**UV REPLACEMENT AT HAVERSTRAW ELEMENTARY SCHOOL**

**MSA File No. 41048**

**NOTICE TO BIDDERS**

**Re: ADDENDUM NO. 7**

Drawing No.  
**E-101**

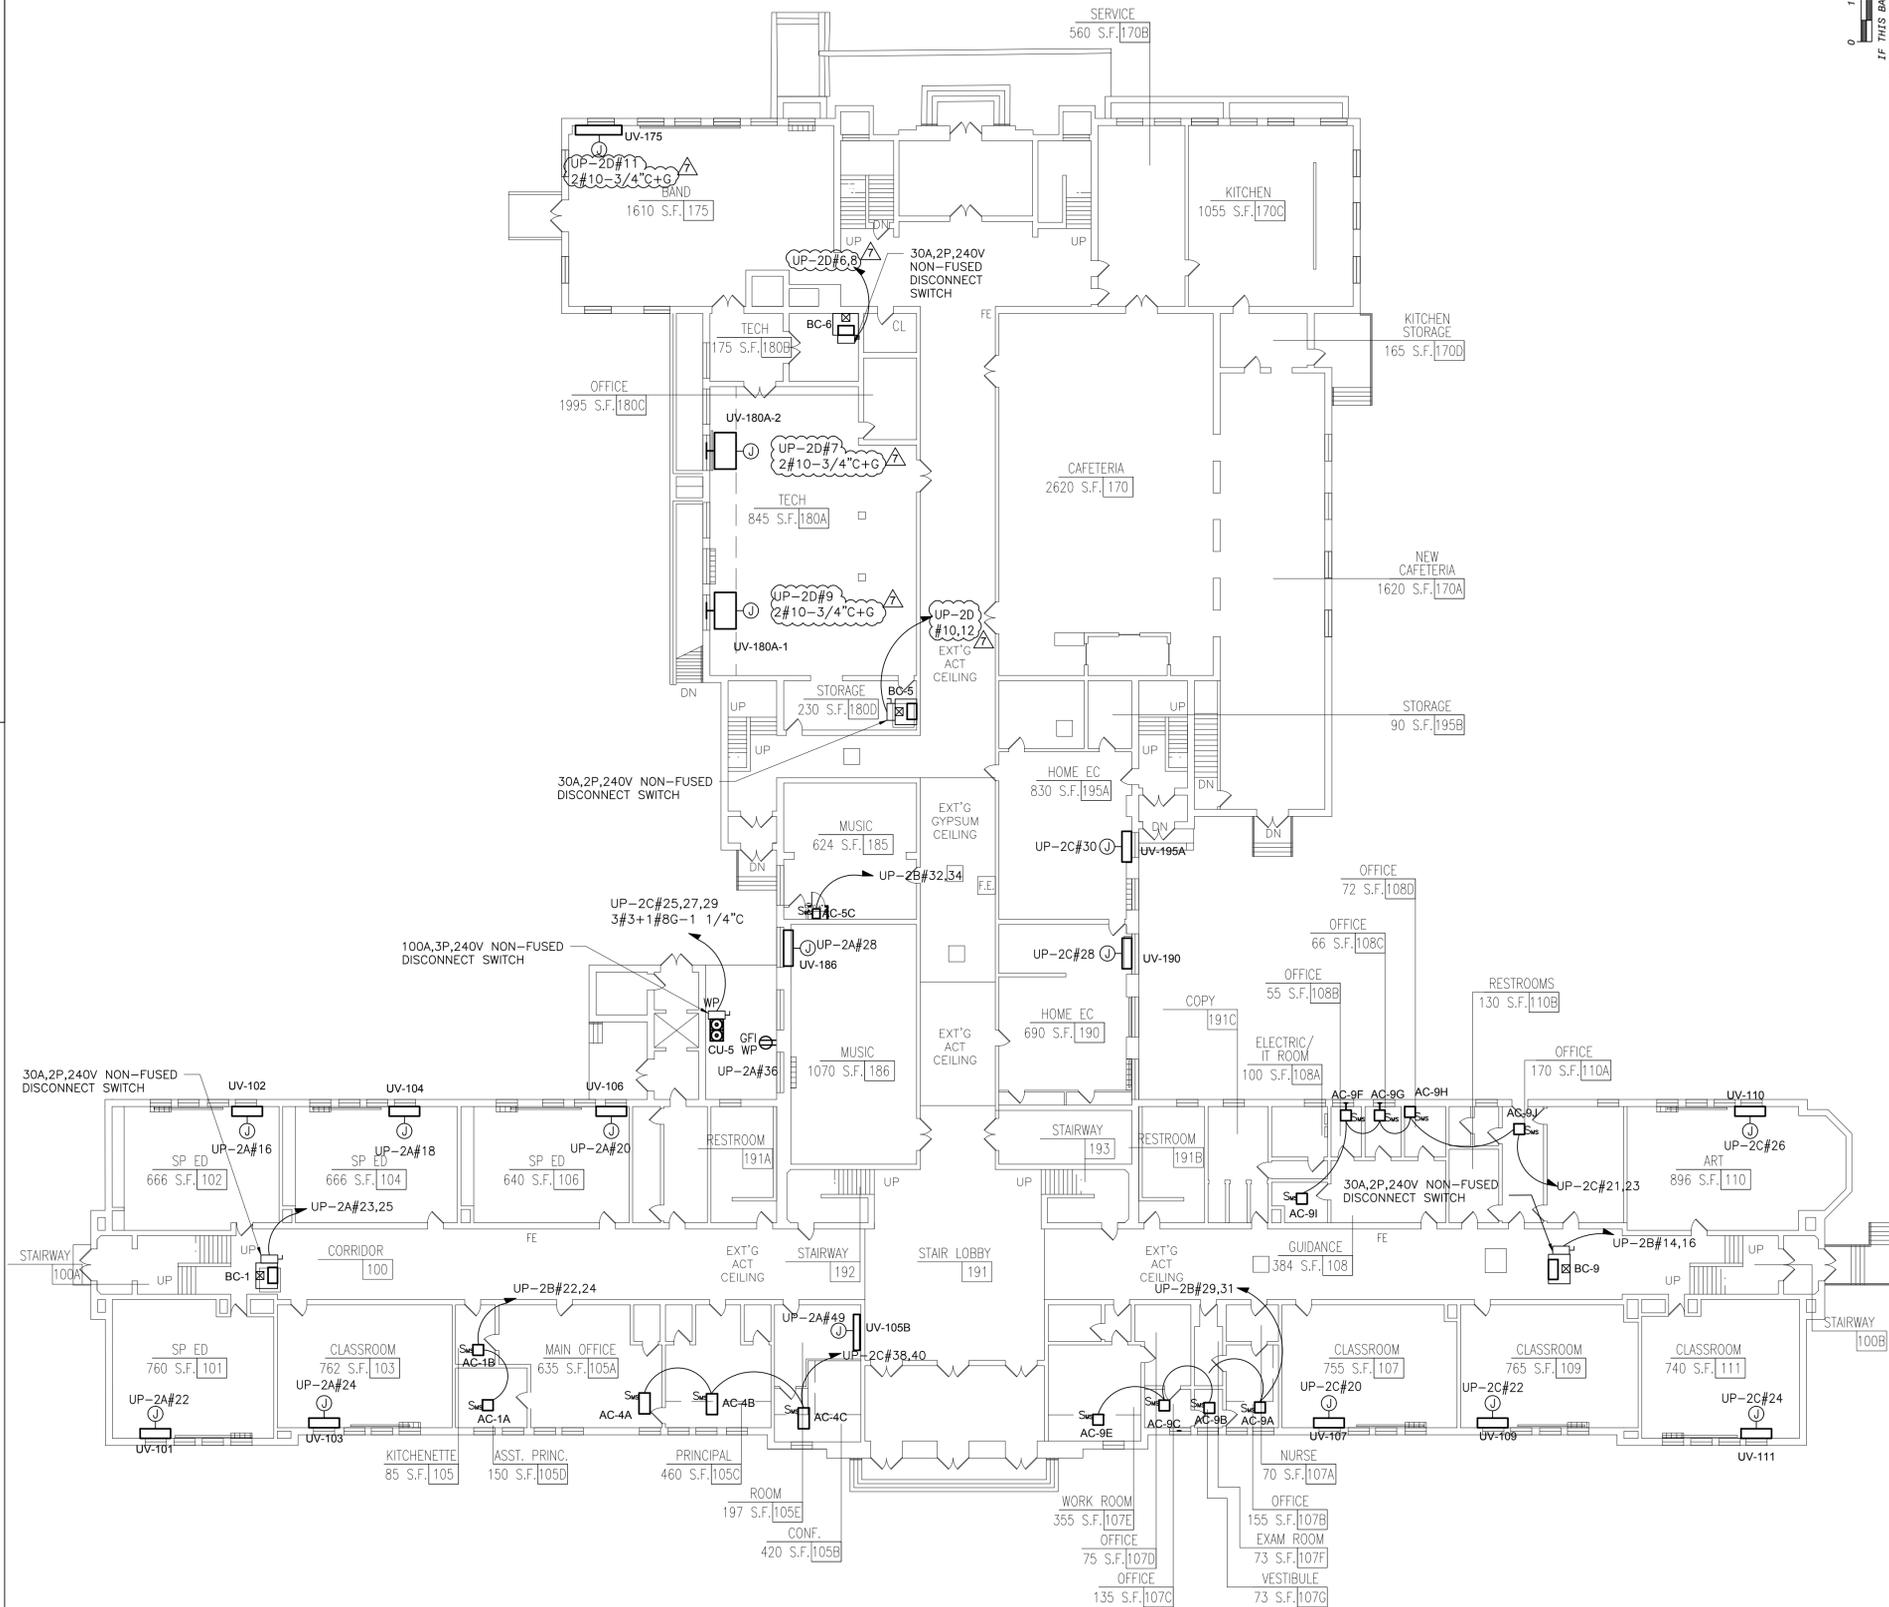
- 6) Electrical drawings have been revised. Base bid work has been revised to provide a new electric panel on the second floor. See attached revised drawings E-101, E-102, E-103, E-104 and E-201 dated 02-17-22. Remove originals and replace with attached.
